**SEQUOYAH NUCLEAR PLANT (SQN) - UNITS 1 AND 2 - TECHNICAL SPECIFICATION (TS) CHANGE NO. 01-08, "INCREASE MAXIMUM ALLOWED REACTOR POWER LEVEL TO 3455 MEGA-WATT THERMAL (MWt)"**

#### PROPOSED TECHNICAL SPECIFICATION (TS) CHANGE NO. 01-08 DESCRIPTION AND EVALUATION OF THE PROPOSED CHANGE

**PROPOSED TECHNICAL SPECIFICATION (TS) CHANGE 01-08  
MARKED PAGES**

FIGURE 3.4-2 SEQUOYAH UNIT 2 REACTOR COOLANT SYSTEM HEATUP LIMITATIONS  
APPLICABLE UP TO ~~16~~ EFY

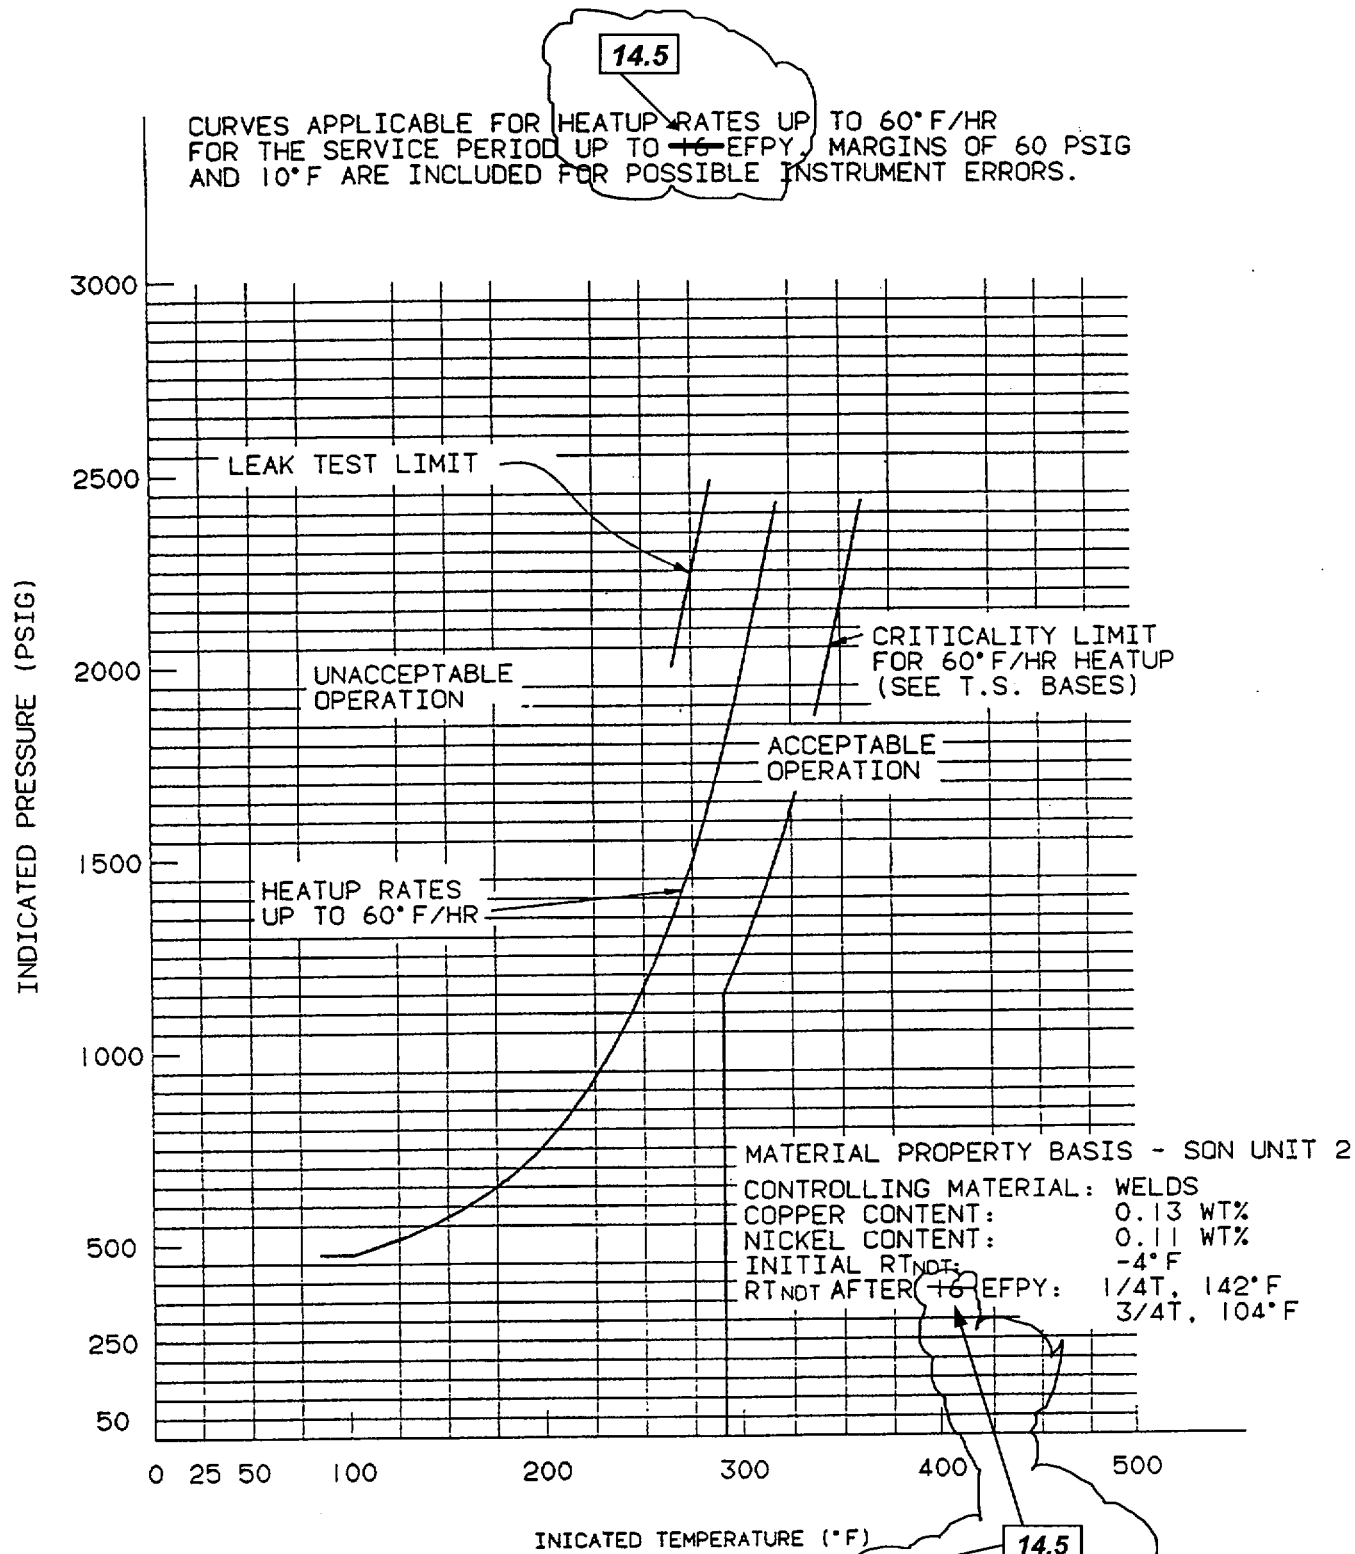
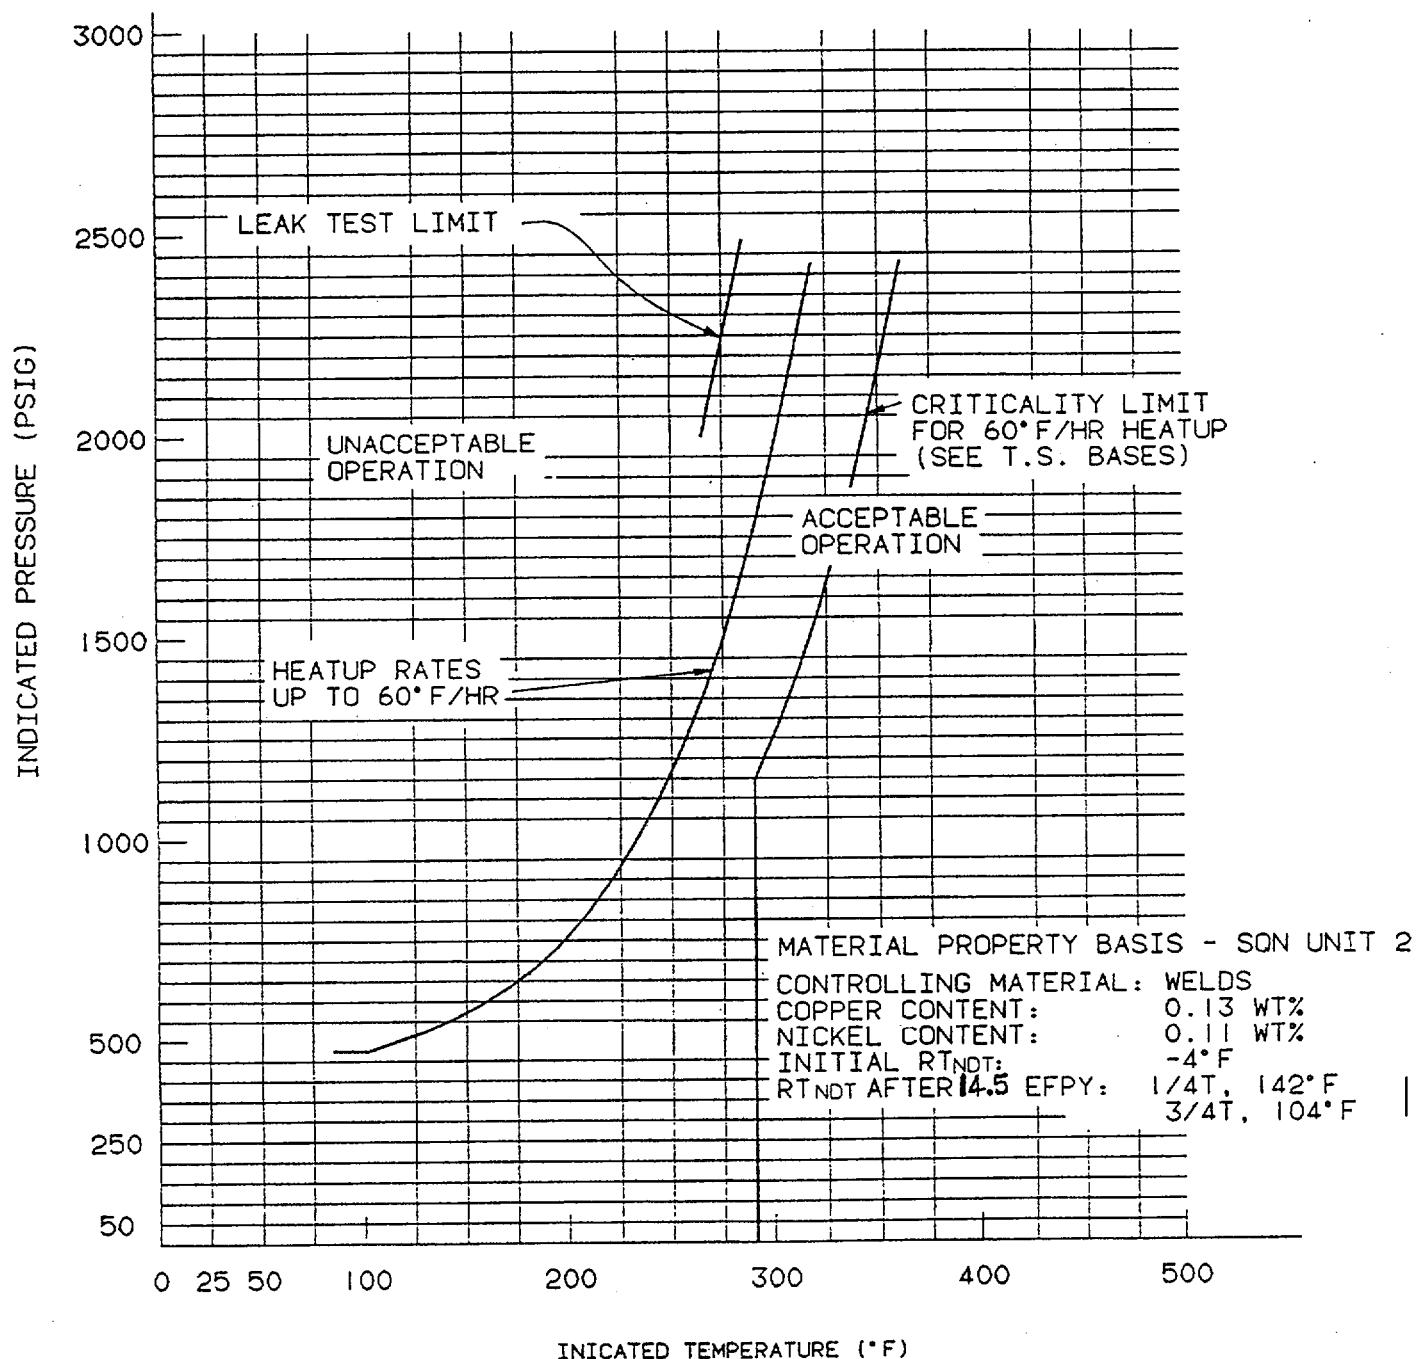
The heatup and cooldown curves for Unit 2 are now applicable for 14.5 EFPY instead of 16 EFPY. The heatup and cooldown curves define limits that still ensure the prevention of nonductile failure for the SQN Units 1 and 2 reactor coolant system (RCS). The design-basis events that were protected have not changed. This modification does not alter any assumptions previously made in the radiological consequence evaluations nor affect mitigation of the radiological consequences of an accident described in the Updated Final Safety Analysis Report. Therefore, the proposed changes will not significantly increase the probability or consequences of an accident previously evaluated.

The reactor vessel materials have been tested to determine their initial  $RT_{NDT}$ ; the results of these tests are shown in Table B 3/4.4-1. Reactor operation and resultant fast neutron (E greater than 1 MEV) irradiation can cause an increase in the  $RT_{NDT}$ . Therefore, an adjusted reference temperature, based upon the fluence of the material in question, has been predicted using Regulatory Guide 1.99, Revision 2 and a peak surface fluence of  $0.864 \times 10^{19}$  n/cm<sup>2</sup> for 16 effective full power years (Reference WCAP 12971, "Heatup and Cooldown Limit Curves for Normal Operation," June 1991. The heatup and cooldown limit curves of Figures 3.4-2 and 3.4-3 include predicted adjustments for this shift in  $RT_{NDT}$  at the end of 16 EFPY, as well as adjustments for possible errors in the pressure and temperature sensing instruments. The heatup and cooldown limits in WCAP-12971 were based on a core thermal power of 3411 MWt. The curves have been evaluated in WCAP-15725 to be effective for operation through the end of 14.5 EFPY for the uprated core thermal power of 3455 MWt.

FIGURE 3.4-2 SEQUOYAH UNIT 2 REACTOR COOLANT SYSTEM HEATUP LIMITATIONS  
APPLICABLE UP TO 14.5 EFY

FIGURE 3.4-4

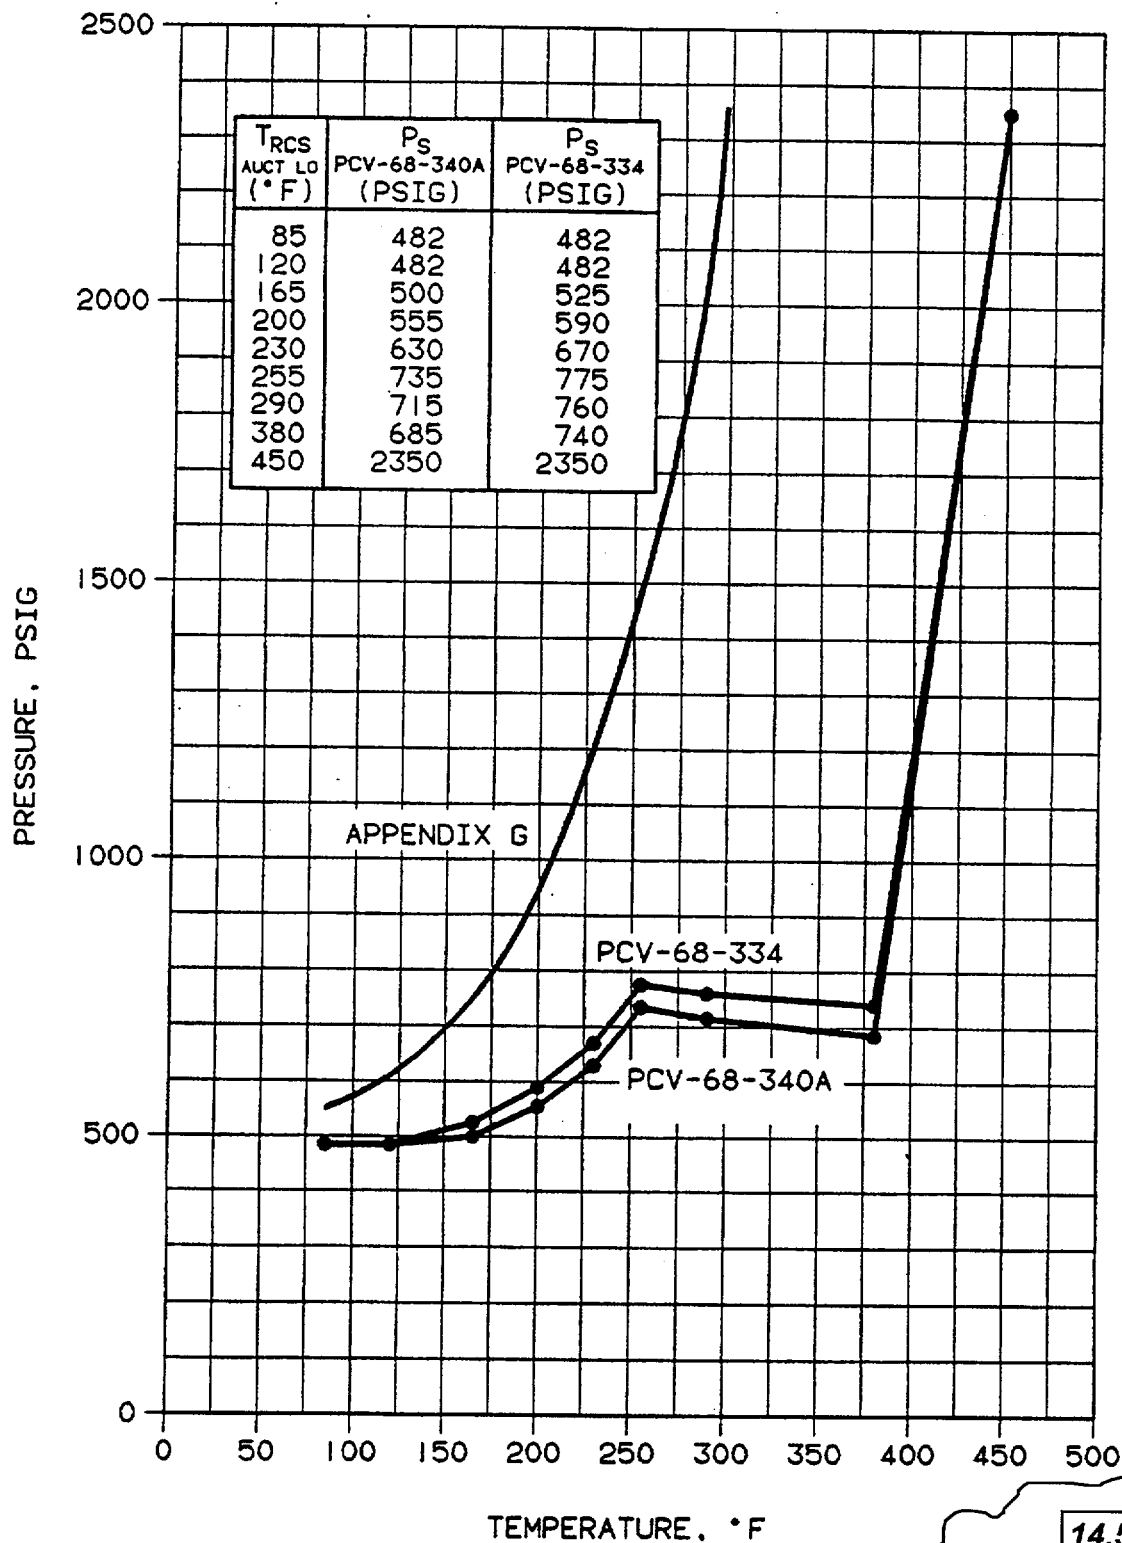
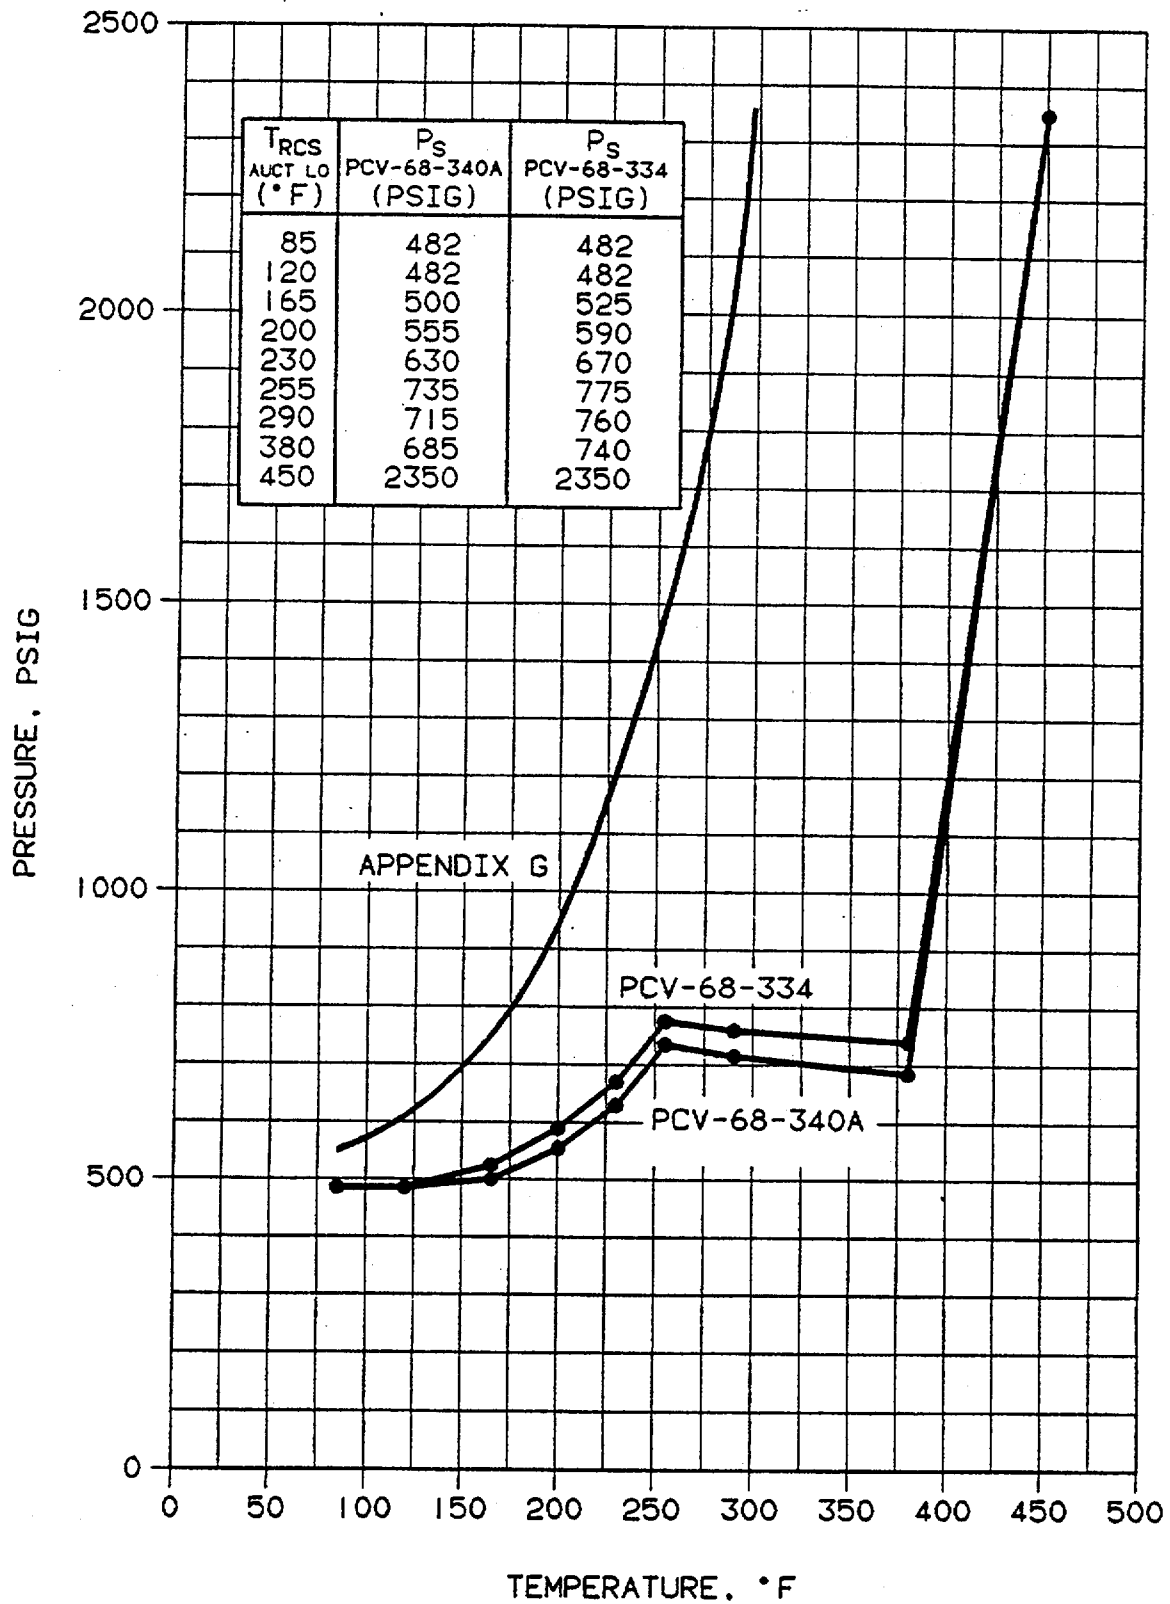
PORV NOMINAL LIFT SETTINGS - APPLICABLE UP TO +6 EFPY

PORV NOMINAL LIFT SETTINGS - APPLICABLE UP TO 14.5 EFY
